Land at Bird in Eye Farm
South of Bird in Eye Hill
Uckfield

Planning Reference: WD/2021/2198/MAO

HIGHWAY NOTE

MT/5330/HN.2
November 2022

Site Access &
Level Drawing

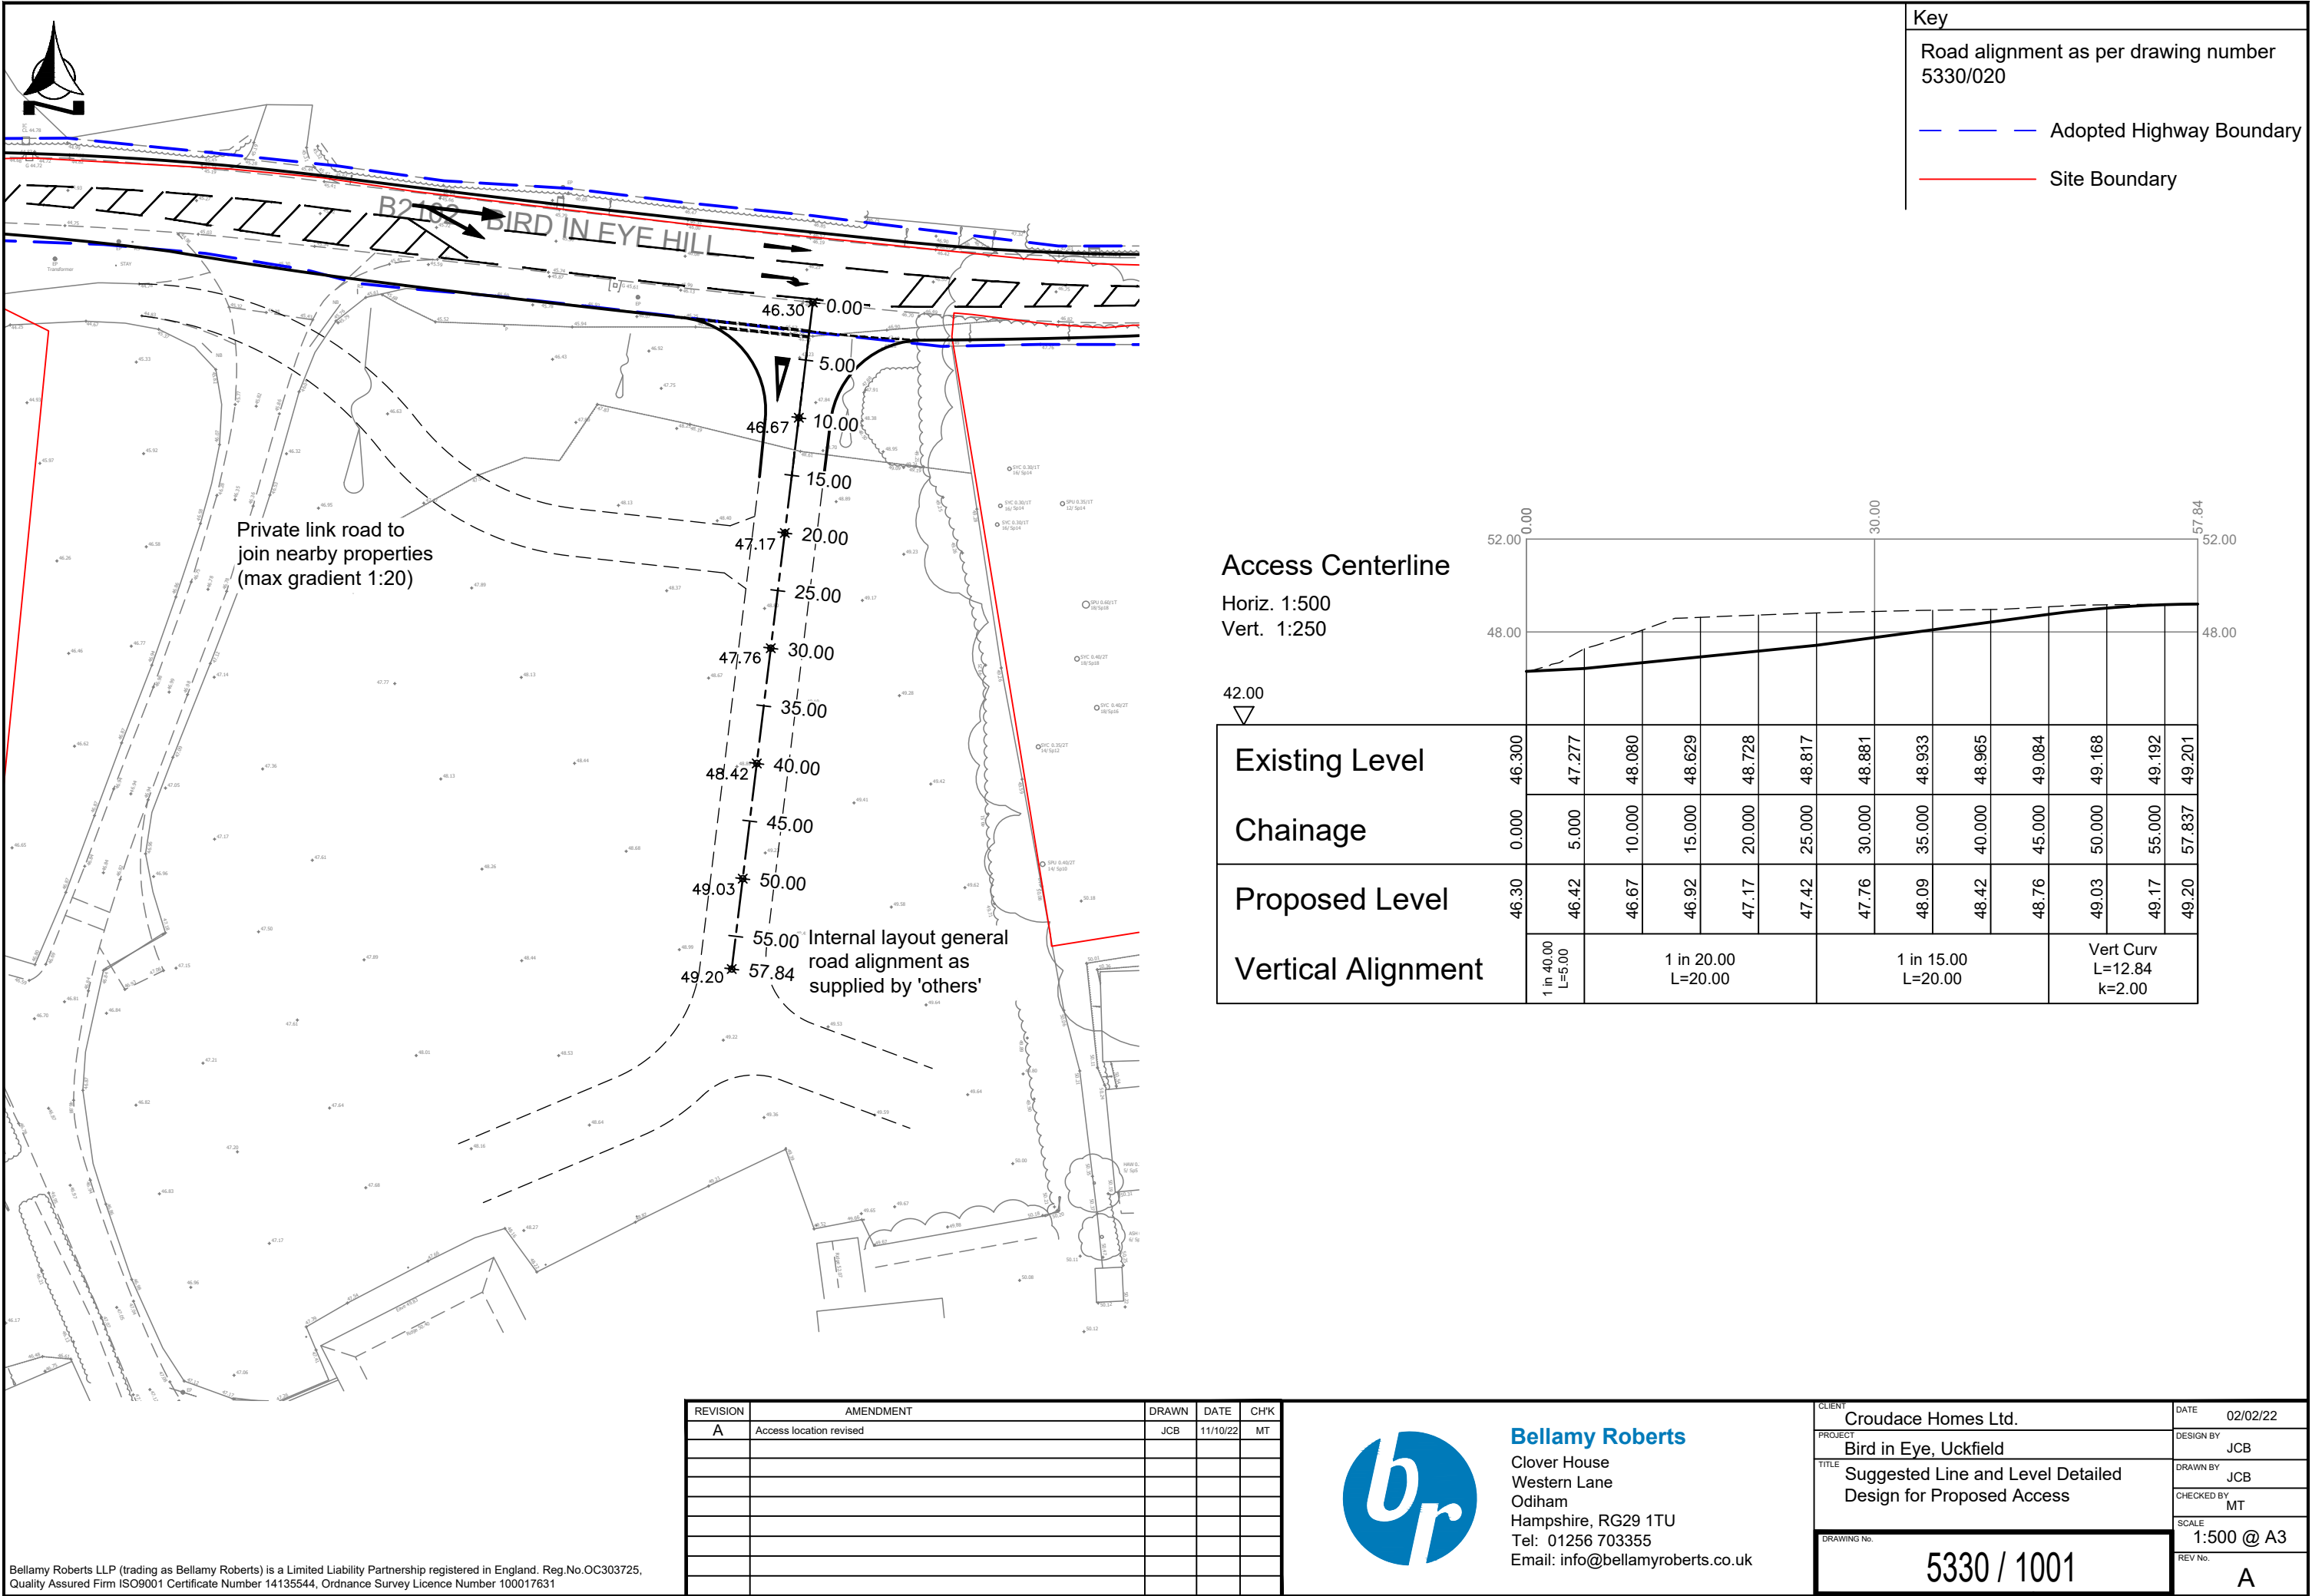
- 2.17** **Dependant on the access being accepted in terms of position, the details such as cross sections, gradient or junction geometry will be required.**

A.1	LOCAL ALIGNMENT
A.1.1	PROBLEM
Location:	Proposed access
Summary:	Vehicles may approach Bird in Eye Hill at inappropriate speeds
Acc Type:	Junction overshoot type collision
<p>The application site is currently set at a level above the adjacent Bird in Eye Hill with the existing access rising gradually away from the main carriageway. The proposals relocate the existing access to Bird in Eye Farm in order to serve a proposed development of 300 residential dwellings as well as two existing dwellings outside of the application site. The scheme drawings do not identify the gradient of the proposed carriageway at this stage, however, the land in proximity appears to be approximately 2 to 2.5 metres higher than the level of the existing carriageway. A gradient in excess of 1 in 20 on approach to a simple priority access could lead to junction overshoot type incidents.</p>	
RECOMMENDATION:	
It is recommended that the access road is set at a maximum gradient of 4%

- 2.18** The proposed line and level drawing for the site access is provided at [Appendix 3](#).

<p>Location Plan:</p>  	
<p>DESIGN ORGANISATION RESPONSE provided by Bellamy Roberts on the 2nd Nov. '22 following formal issue of this Stage 1 Road Safety Audit on the 20th Oct. '22</p>	
<p>Agreed - The proposed access will be designed with a 1:20 gradient, graded up away from the carriageway. See drawing 5330/1001 rev. A.</p>

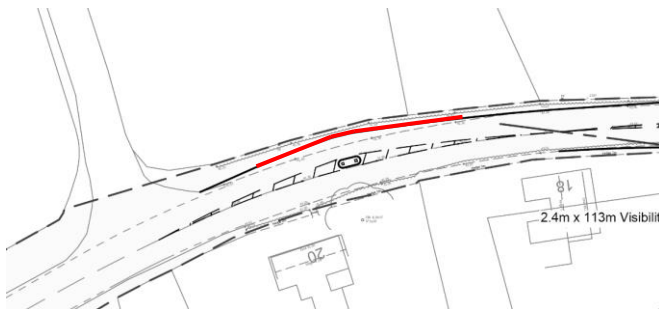
A.1.2	PROBLEM
Location:	Bird in Eye Hill
Summary:	Tapers associated with proposed splitter island do not generate a smooth alignment
Acc Type:	Kerb strike and loss of control type collision
<p>The B2102 Bird in Eye Hill accommodates a number of bends and is currently derestricted, therefore subject to a 60mph speed limit, but according to data contained within the Audit Brief, observes 85th percentile eastbound speeds of 39.9mph and westbound speeds of 43.4mph. The proposals include the provision of a priority access off the southern side of the carriageway. As part of the works, a splitter island is to be provided to the west of the proposed access in order to prevent eastbound traffic from crossing into the opposing lane whilst approaching the proposed access and therefore allow for a visibility splay in accordance with observed speeds to extend to the road centreline. The scheme drawing illustrates that the 1.1 metre wide splitter island is to be situated along the bend in the road and provided through widening the carriageway to the north only, by 1.35 metres. The tapers associated with the proposed island measure 25 metres in length and extend to a point 300mm from the physical island. It can therefore be determined that the tapers on the eastbound approach and exit, equate to circa. 1 in 12.5. Due to the bend in the road, the approach appears smooth, however, the path through and exit appear to be formed with abrupt changes. Sharp changes in the alignment could lead to vehicles striking the kerbline or the physical island and loss of control type collisions.</p>

RECOMMENDATION:	
It is recommended that the tapers are elongated to allow for a smooth alignment	
Location Plan:  	
DESIGN ORGANISATION RESPONSE provided by Bellamy Roberts on the 2 nd Nov. '22 following formal issue of this Stage 1 Road Safety Audit on the 20 th Oct. '22	
See response to item A.2.2.

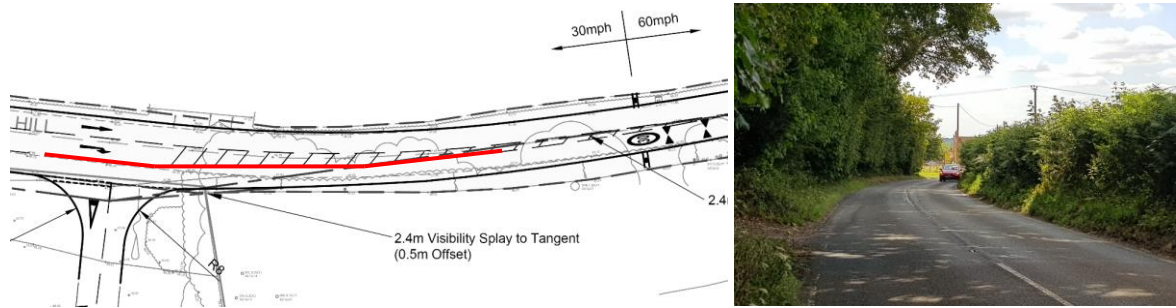
A.1.3	PROBLEM
Location:	Bird in Eye Hill
Summary:	Proposed westbound entry taper does not allow for a smooth alignment
Acc Type:	Sideswipe loss of control type collision
<p>The B2102 Bird in Eye Hill accommodates a number of bends and is currently derestricted, therefore subject to a 60mph speed limit, but according to data contained within the Audit Brief, observes 85th percentile eastbound speeds of 39.9mph and westbound speeds of 43.4mph. The proposals include the provision of a 3.0 metre wide right turn lane that is to allow access to a proposed priority access off the southern side of the carriageway. In order to provide the right turn lane, the carriageway is to be widened on both sides; marginally to the north and by 2.75 metres to the south. The scheme drawing illustrates that the westbound road centreline to the east is to follow a taper that is 75 metres long equating to 1 in 25, however, the taper does not appear to follow the edge of carriageway or generate a smooth alignment for westbound traffic. The abrupt change in direction could lead to traffic encroaching the proposed right turn lane, taking the desire line and sideswipe or loss of control type collisions.</p>

RECOMMENDATION:	
It is recommended that the taper is amended to allow a smooth alignment	
Location Plan:

DESIGN ORGANISATION RESPONSE provided by Bellamy Roberts on the 2nd Nov. '22 following formal issue of this Stage 1 Road Safety Audit on the 20th Oct. '22	
Agreed - The proposed taper has been amended to follow the proposed nearside edge of carriageway and generate a smooth alignment. See drawing 5330/021 rev J.	
A.2	GENERAL
A.2.1	PROBLEM
Location:	Bird in Eye Hill
Summary:	Proposed through lanes may not be adequate for the expected vehicles
Acc Type:	Sideswipe type collisions
<p>The B2102 Bird in Eye Hill is a two-way single carriageway road that is circa. 5.75 metres wide (according to the topographical survey upon which the scheme drawing is based), bounded by hedgerows in places and derestricted, therefore subject to the 60mph speed limit. The proposals include the provision of a right turn lane in order to allow access to a relocated priority access off</p>

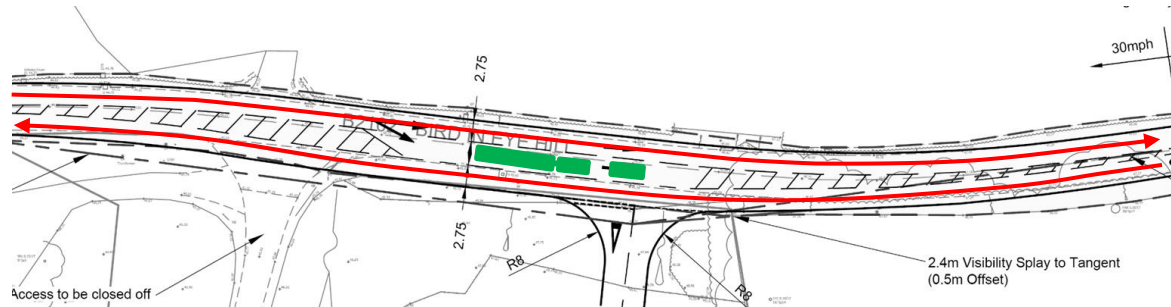
the southern side of the carriageway simple priority access off the southern side the carriageway. The proposed right turn lane is to be 3.0 metres wide with 2.75 metre through lanes. The Audit Team understand that a lane width reduction from 2.85 metres to 2.75 metres, can and does act as a traffic calming feature, however, have concerns that the proposed through lanes are too narrow for the expected vehicles. Narrow through lanes through could result in the need for vehicles to encroach the proposed right turn lane where vehicles could be waiting leading to sideswipe type collisions.

RECOMMENDATION:

It is recommended that the proposed through lanes are adequate for the expected vehicles

DESIGN ORGANISATION RESPONSE provided by Bellamy Roberts on the 2nd Nov. '22 following formal issue of this Stage 1 Road Safety Audit on the 20th Oct. '22

Agreed - The existing Bird in Eye Hill carriageway is approximately 5.5m wide with lane widths of approximately 2.75m. These existing lane widths will remain constant through the proposed scheme. Nevertheless, swept path analysis has been undertaken which indicates that the 2.75 metre through lane width is adequate. See drawing 5330/239.

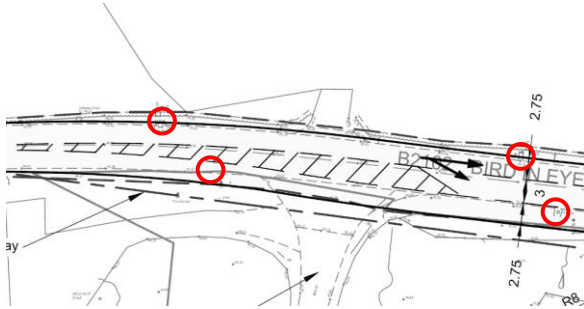
A.2.3	PROBLEM
Location:	A2102 Bird in Eye Hill
Summary:	Existing road gullies will be within the path of vehicles
Acc Type:	Vehicle loss of control
<p>Bird in Eye Hill is cambered with surface water falling to the channels either side of the carriageway where soft verges and road gullies are present, some of which are offline and situated within a cut-out in the verge. During the site visit associated with this Audit, a number of gullies in proximity to the proposed works were observed to be blocked, although no ponding was present. The proposals introduce a right turn lane by widening both sides of the carriageway where gullies are present. No details of the proposed surface water drainage have been provided at this stage. A road gully within the path of a vehicle, particularly for two wheeled vehicles could lead to a loss of control type collision as would ponding as a result of an insufficient surface water drainage network.</p>

RECOMMENDATION:	
It is recommended that the existing gullies are removed, and an adequate surface water drainage network is provided.

Location Plan:   	
DESIGN ORGANISATION RESPONSE provided by Bellamy Roberts on the 2 nd Nov. '22 following formal issue of this Stage 1 Road Safety Audit on the 20 th Oct. '22	
Agreed - All existing gullies will be reviewed during the detail design of the scheme.	
A.2.4	PROBLEM
Location:	Bird in Eye Hill
Summary:	Existing utility covers and telegraph / electric poles are present
Acc Type:	Loss of control type collision
<p>The B2102 Bird in Eye Hill accommodates a number of utility covers and poles in the verge to the south of the carriageway. The proposals include highway works to provide a right turn lane and priority access off the southern side of the carriageway. Observations show that a triple utility cover and telegraph / electric poles are present within the area of the works. The items will be an obstruction unless relocated accordingly which could lead to loss of control type collisions.</p>

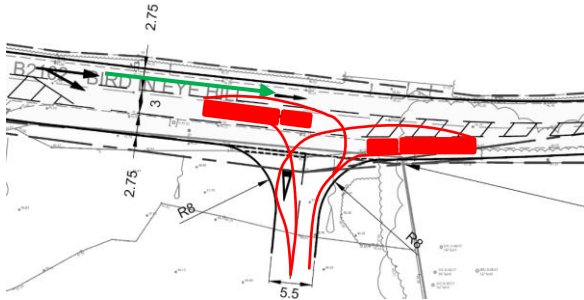
RECOMMENDATION:	
It is recommended that the utility covers and poles are relocated accordingly.	
Location Plan:  	
DESIGN ORGANISATION RESPONSE provided by Bellamy Roberts on the 2 nd Nov. '22 following formal issue of this Stage 1 Road Safety Audit on the 20 th Oct. '22	
Agreed – All existing services and utilities will be assessed during the detail design of the scheme.

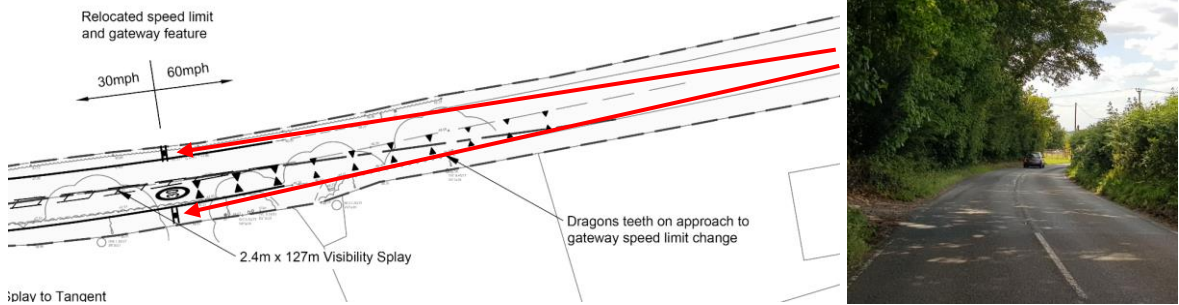
A.3	JUNCTIONS
A.3.1	PROBLEM
Location:	Proposed access arrangement
Summary:	Vehicles may encroach the opposing lane when manoeuvring
Acc Type:	Sideswipe type collisions
<p>The existing access to Bird in Eye Farm is approximately 5 metres wide with large corner radii that appear to have been extended to incorporate tapers which is likely to have been as a result of Heavy Goods and Agricultural Vehicles encroaching outside the original carriageway. The proposals include the relocation of the priority junction that is to allow access to a 5.5m wide carriageway and be formed with 8 metre radii. The Audit Brief does not include a plan illustrating a swept path analysis and therefore the Audit Team are unsure if the expected vehicles can be accommodated within the carriageway. It is understood that the existing commercial uses that are accommodated at Bird in Eye Farm, are to be retained and whilst no details have been provided to identify the expected vehicles, there are concerns that large vehicles will encroach the opposing lanes of traffic. Whilst the front end of a large vehicle encroaching the opposing lane of traffic is generally not a road safety concern when infrequent on lightly trafficked roads like the existing access as a driver would not proceed until it is safe to do so, the manoeuvre undertaken frequently when opposed is likely to lead to head-on and rear end type collisions as a result of heavy braking. Further, the trailer of a large vehicle swinging out into the path of opposing traffic will not be expected and could lead to sideswipe and loss of control type collisions.</p>

RECOMMENDATION:	
It is recommended that an entry and exit taper is provided to allow for the expected vehicles to manoeuvre with minimal impact on opposing traffic.	
Location Plan: <div style="display: flex; align-items: center;">   </div>	
DESIGN ORGANISATION RESPONSE provided by Bellamy Roberts on the 2 nd November 22 following formal issue of this Stage 1 Road Safety Audit on the 20 th Oct. '22	
Disagree - Swept path analysis of a large rigid vehicle and refuse vehicle accessing and exiting the site has been undertaken, demonstrating that the proposed access is suitable to serve the scheme. See drawings 5330/227 & 228.
